**Wisconsin Electric** POWER COMPANY  
231 W. MICHIGAN, P.O. BOX 2046. MILWAUKEE, WI 53201

DOCKET NOS. 50-266 AND 50-301  
ASME SECTION XI RELIEF REQUESTS  
POINT BEACH NUCLEAR PLANT, UNITS 1 AND 2

UNITS 1 AND 2 RELIEF REQUEST

FIGURE 1

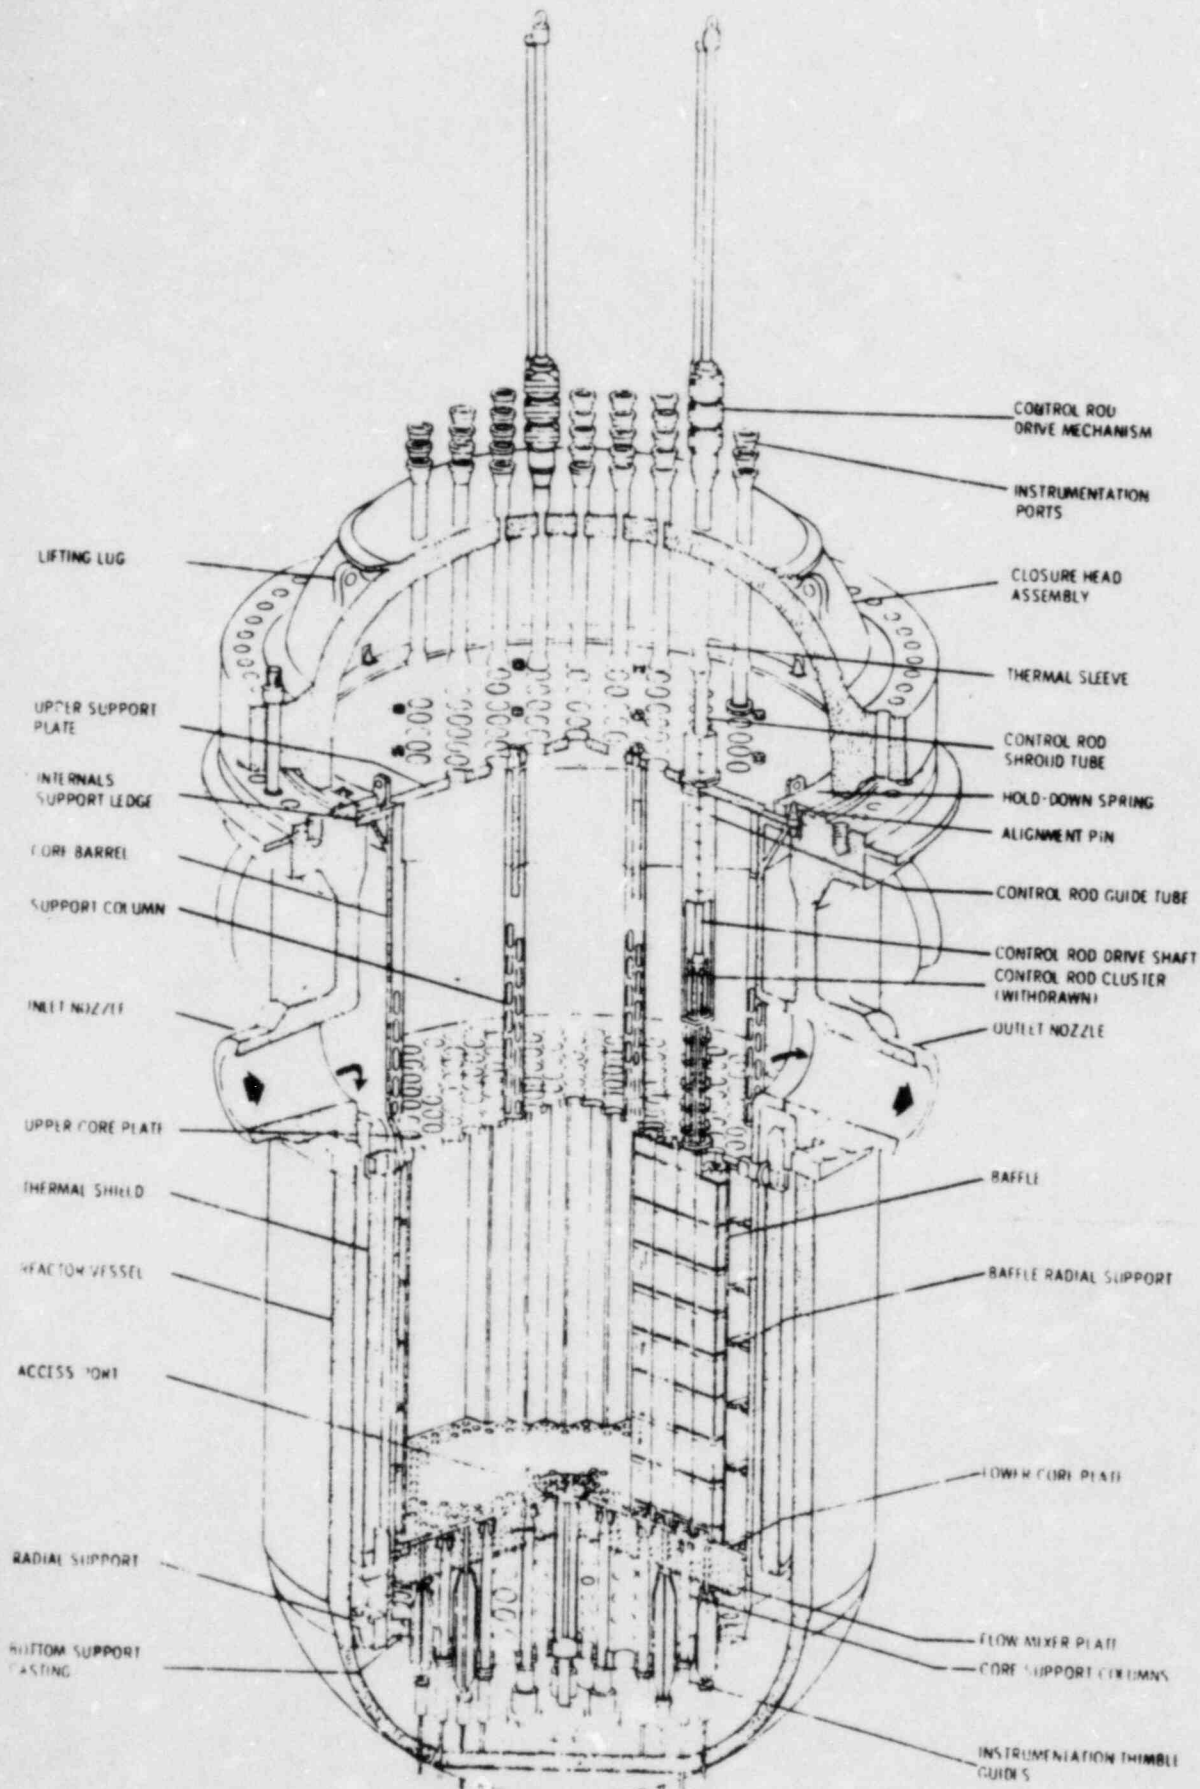
As can be seen from Figure 1, only a small portion of the reactor vessel interior surfaces are accessible with the core barrel in place. There is approximately 10" of the vessel interior surface accessible from the top of the core barrel flange to the reactor vessel flange during a normal refueling outage. A meaningful examination cannot be performed unless the core barrel is removed. Removal of the core barrel requires a complete defueling of the reactor and significant ALARA impacts including exposure and contamination problems.

A visual examination (VT) of the reactor vessel interior will be performed when the core barrel is removed but not at a frequency greater than that specified in the Code. The core barrel will not be removed specifically for this examination.
